QUESTION 2H.1 (DRL 2.7) Discuss the water flow patterns in the vicinity of the plant and their associated consequences on plant operations following a failure of the on-site water storage facilities.

QUESTION  
2H.2  
(DRL 2.8)

Docket 50-312  
Amendment No. 2  
April 15, 1968  
Appendix A to Question 2H.2

**SMUD**  
 SACRAMENTO MUNICIPAL UTILITY DISTRICT

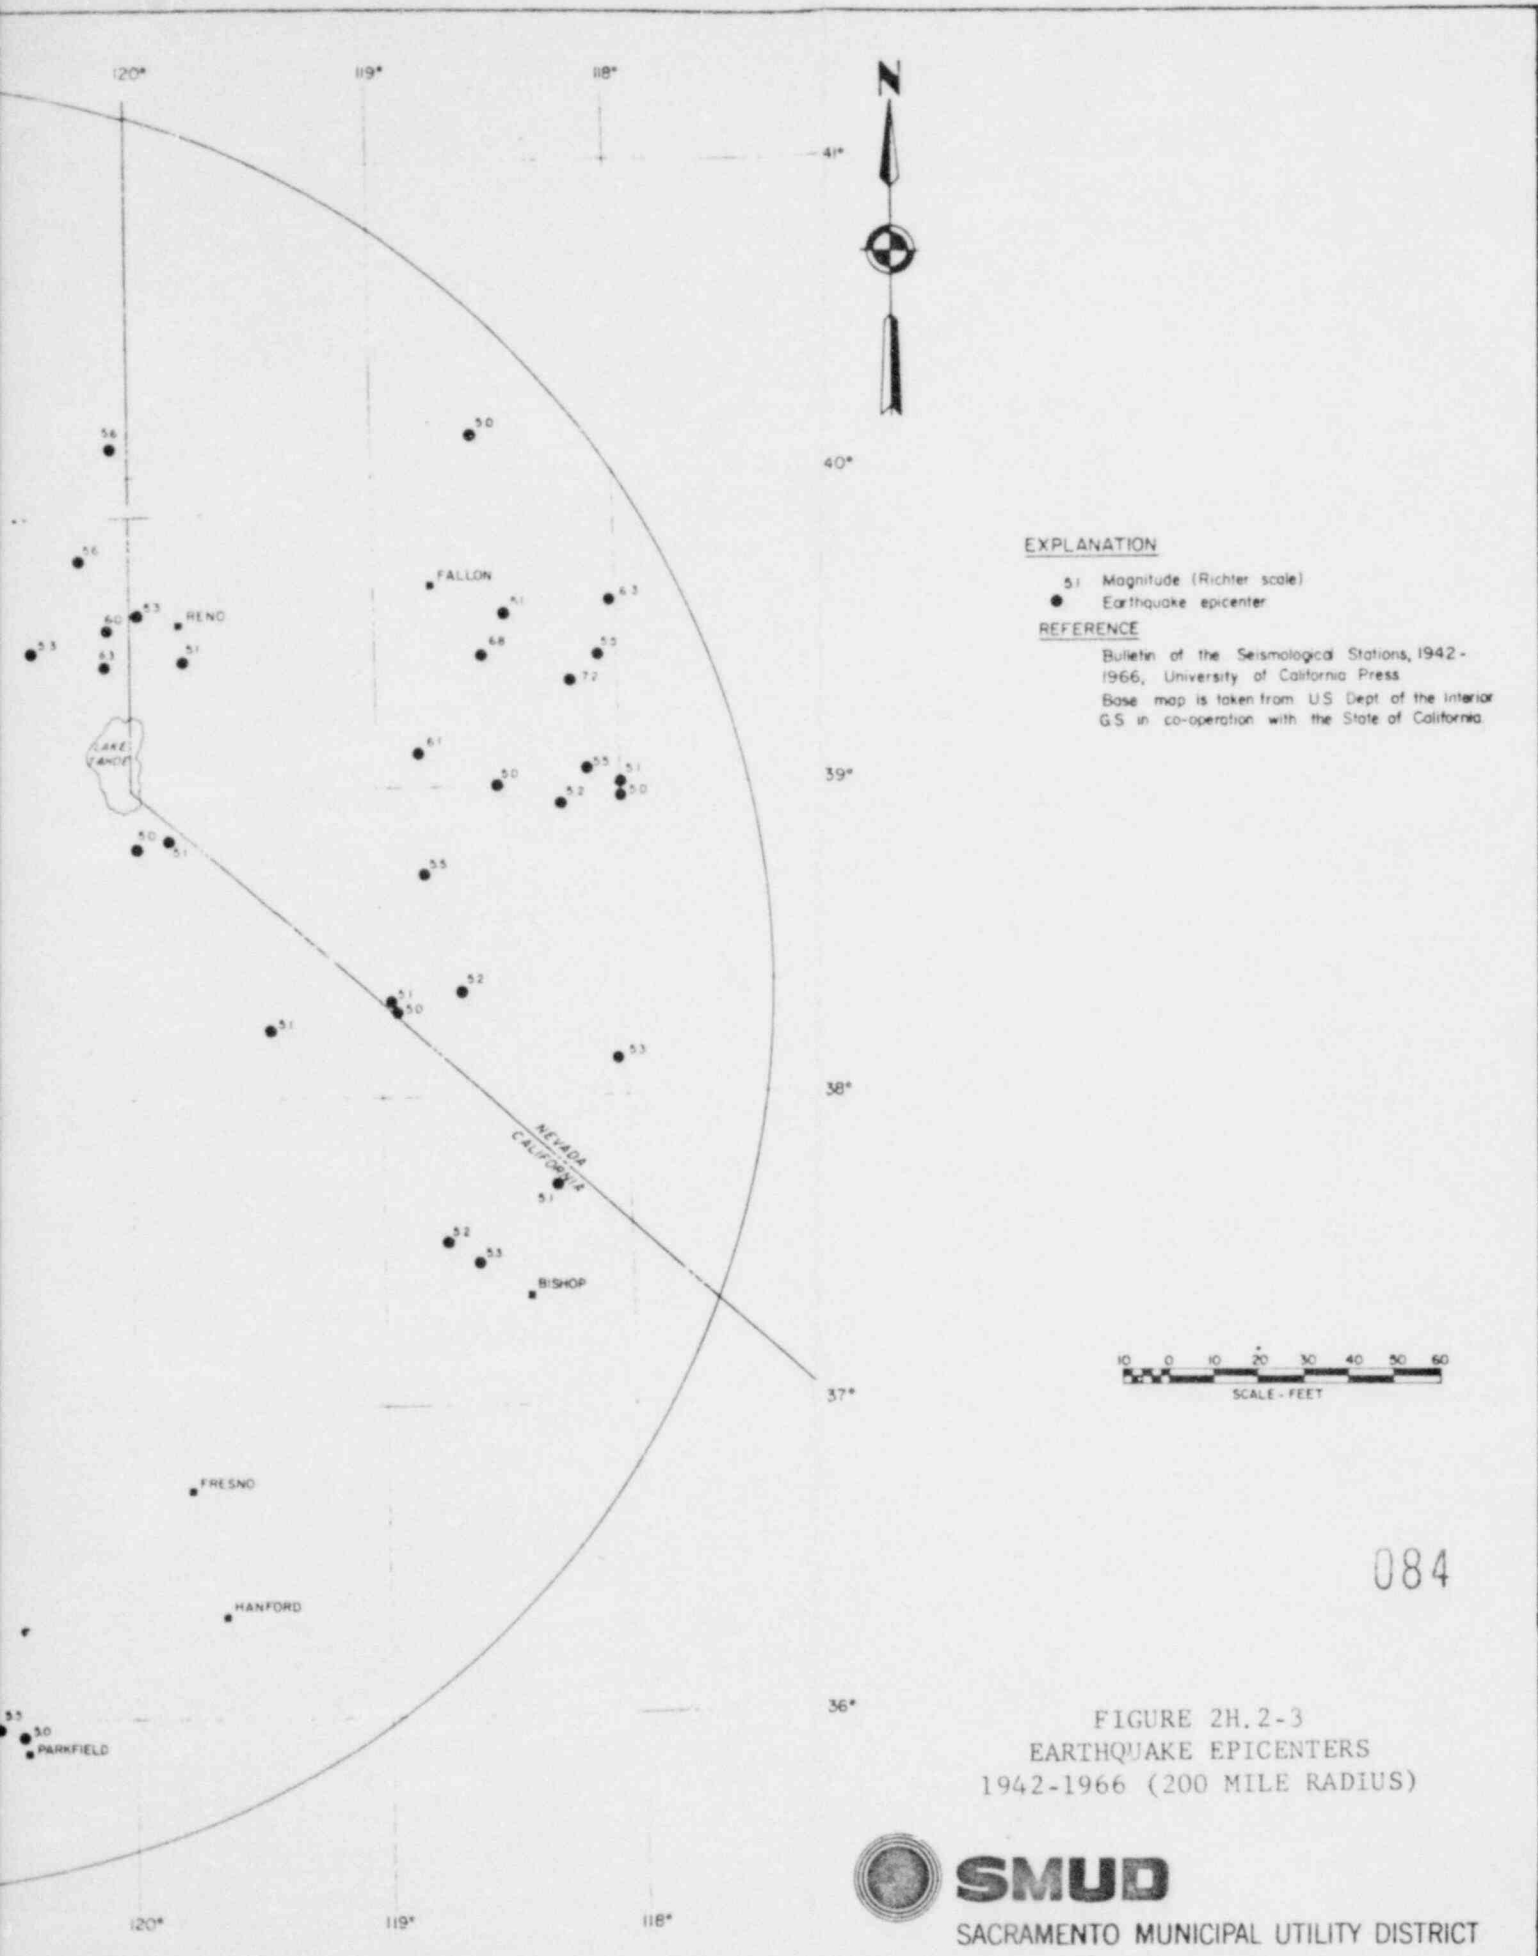
Provide a map of earthquake epicenters within a radius of 200 miles showing all earthquakes of intensity V or greater at the epicenter.

The epicenter map shows the magnitude of earthquakes actually recorded, while the non-instrumented seismic event map shows the highest intensity reported for any earthquake. It is considered that the 50 mile radius map presents a meaningful description of the site and adjacent area since varying geological conditions need not be evaluated. Similar maps for a 200 mile radius are shown in Figures 2H.2-3 and 4.
